SERVICE BULLETIN

M-1183A

SAFETY RECALL 0124–2006 DYNA TRANSMISSION

Figure 6. Primary Drive Locking Tool

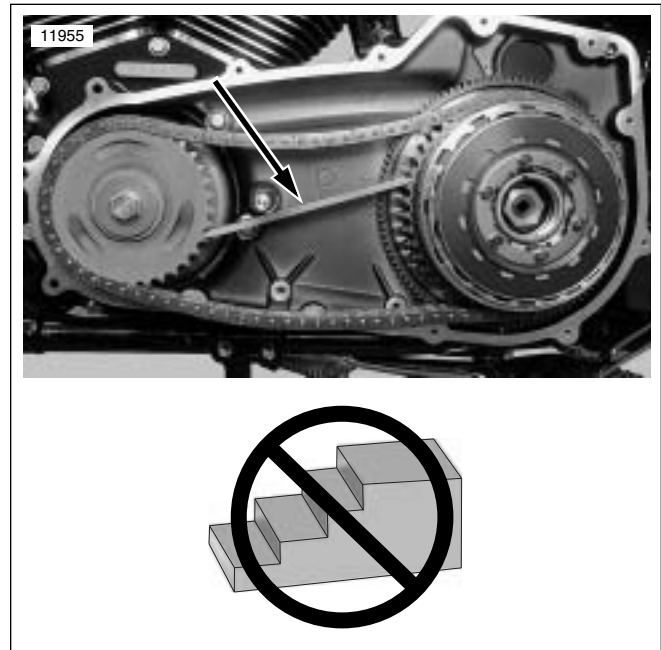
See Figure 6. Do not use HD-41214 Primary Drive Locking Tool to remove or install components. Damage to components can occur if this tool is used. Use only HD-47977 Primary drive locking tool to remove and install components.

Figure 10. Shift Cam and Detent Assembly

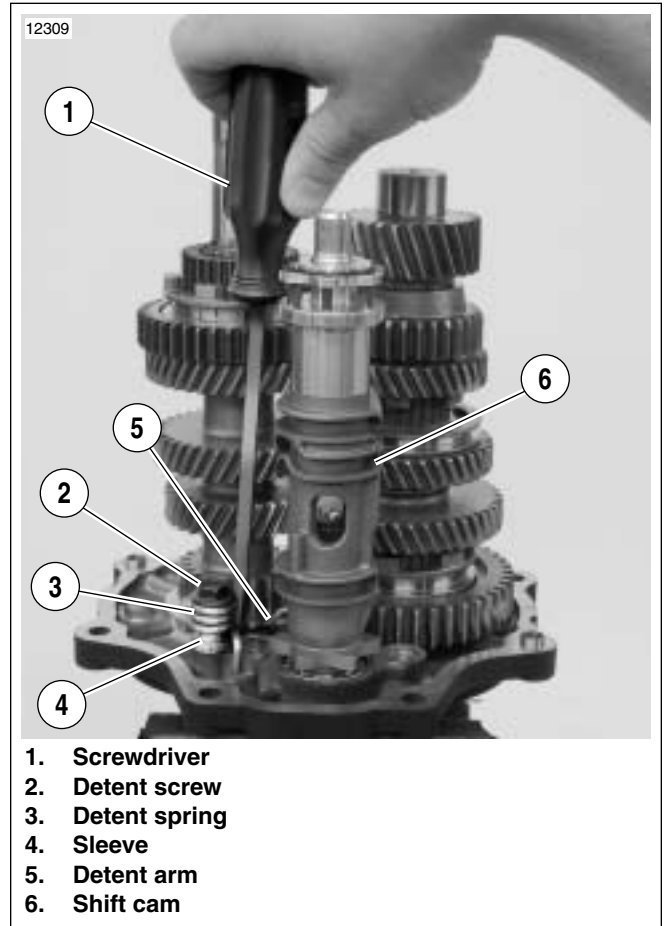
22. See Figure 10. Insert screwdriver (1) and gently pry back detent arm (5) to remove detent spring (3) tension from shift cam (6). Remove shift cam.
23. Remove detent screw (2), detent spring, sleeve (4) and detent arm. Discard detent screw.

3. See Figure 10. Using screwdriver (1), pull detent arm (5) back and install **new** shift cam (6) (Part No. 33413-06 from recall parts kit).

Figure 11. Detent Assembly

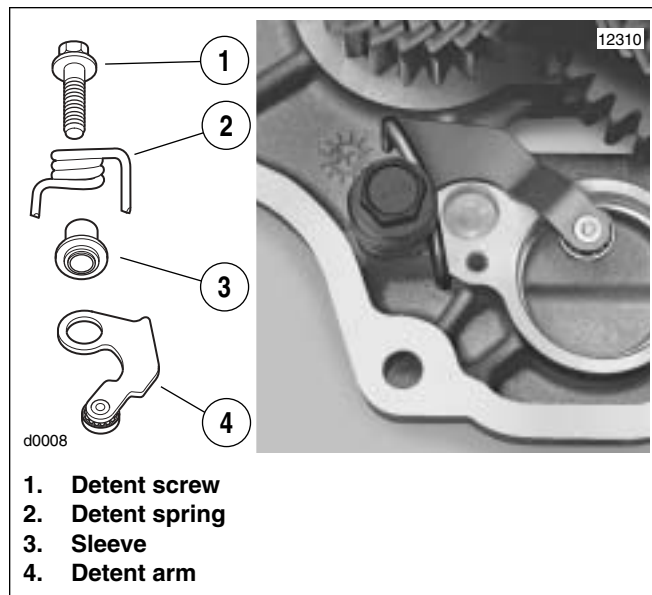
2. See Figure 11. Assemble **new** detent screw (1) (Part No. 35244-06 from recall parts kit), detent spring (2), sleeve (3) and **new** detent arm (4) (Part No. 33409-06 from recall parts kit). With transmission bearing housing mounted on end (shafts pointing upward), mount detent assembly in bearing housing as shown. Make certain to orient spring and detent arm as shown in the figure. Tighten screw to 120-150 **in-lbs** (13.6-17.0 Nm).

Figure 14. Installing Mainshaft Inner Bearing Race

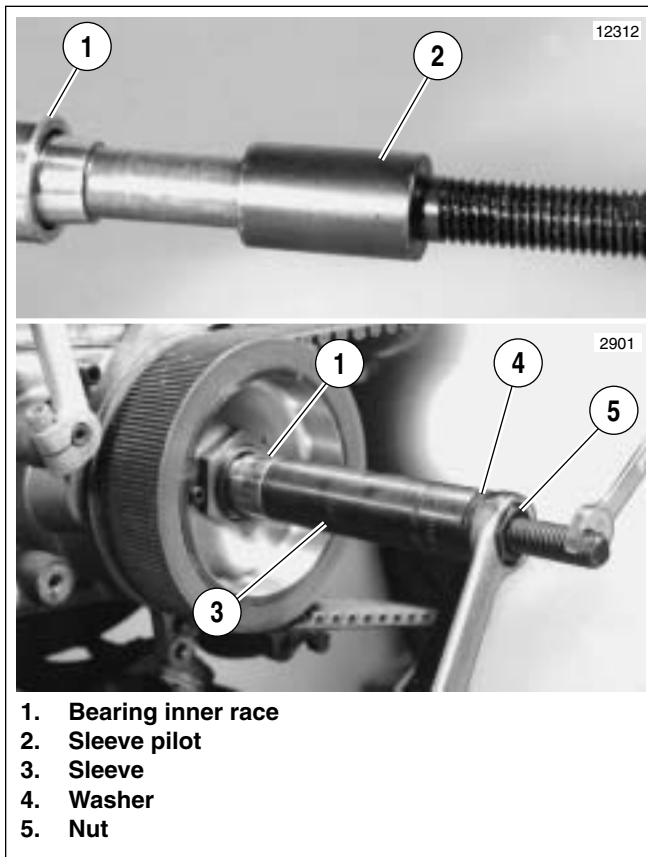
*See Figure 14. The **new** mainshaft inner bearing race (Part No. 34091-06 from recall parts kit) must be positioned on the mainshaft a precise distance to properly align with bearing outer race in inner primary chaincase.*

Do NOT press the inner race all the way against the main drive gear. If the inner race is pressed against the main drive gear, the inner race will be out of alignment with the bearing in the primary housing. This can result in premature bearing failure.

17. See Figure 14. To install **new** mainshaft bearing inner race (1) (Part No. 34091-06 from recall parts kit), use those parts of the combination BEARING RACE PULLER AND INSTALLATION TOOL (Part No. HD-34902-B) that are shown in the figure.
 - a. Slide bearing inner race (1) onto mainshaft with numbered end of race facing away from main drive gear.
 - b. Thread sleeve pilot (2) onto end of mainshaft (left hand thread).
 - c. Position sleeve (3) over sleeve pilot and against bearing inner race.

- d. Place washer (4) over threaded portion of sleeve pilot and install nut (5).
- e. Tighten nut while holding sleeve pilot stationary with wrench on flats at end of screw threads. Press bearing inner race onto shaft so inside edge is 0.100-0.125 in. (2.540-3.180 mm) from main drive gear.

Figure 17. Sealing Fastener (Part No. 786A)

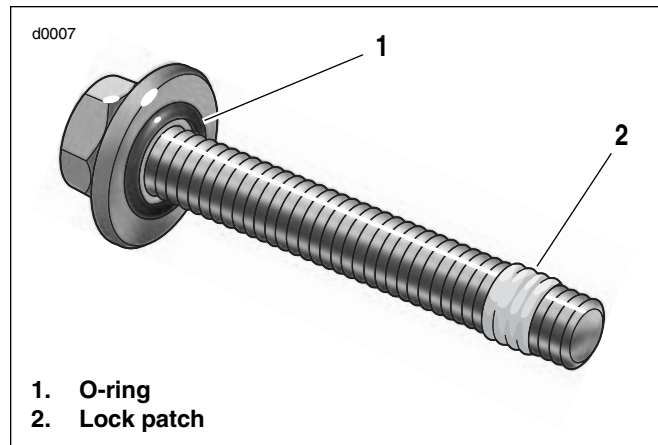
See Figure 17. **New** sealing fasteners (Part No. 786A from recall parts kit) have different head markings and are 1/8 in. longer than old fasteners. New fasteners also have an orange lock patch.

Figure 18. Sealing Fastener Tightening Sequence

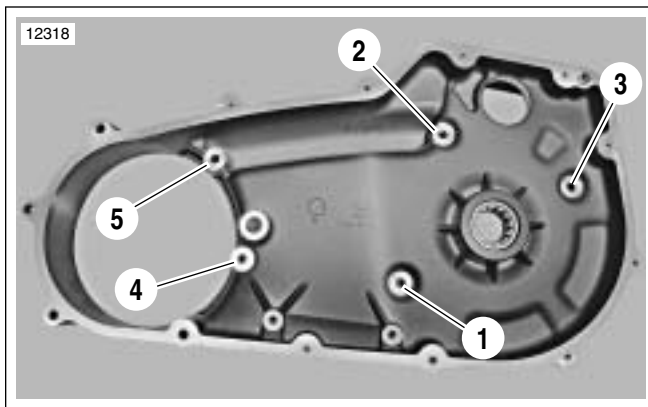
32. See Figure 18. Clean the faces of the five mounting screw bosses in the inner primary housing with PJ1 or equivalent. The boss faces must be clean and dry, free of any oil or other contaminants.
33. Insert five **new** sealing fasteners (Part No. 786A from recall parts kit). Start all five fasteners in holes. Then tighten fasteners in the sequence shown in the figure to 27 ft-lbs (36.6 Nm).
34. Remove seal protector sleeve (or tape) from transmission mainshaft splines.
35. Attach starter motor assembly to inner primary housing with two screws and washers. Tighten to 13-20 ft-lbs (17.6-27.1 Nm). See INSTALLATION under 5.4 STARTER in DYNA MODELS SERVICE MANUAL.
36. Clean the following fastener threads and threaded holes.
 - compensating sprocket bolt,
 - engine sprocket shaft threaded hole,
 - transmission mainshaft threads,
 - clutch hub mainshaft locknut.
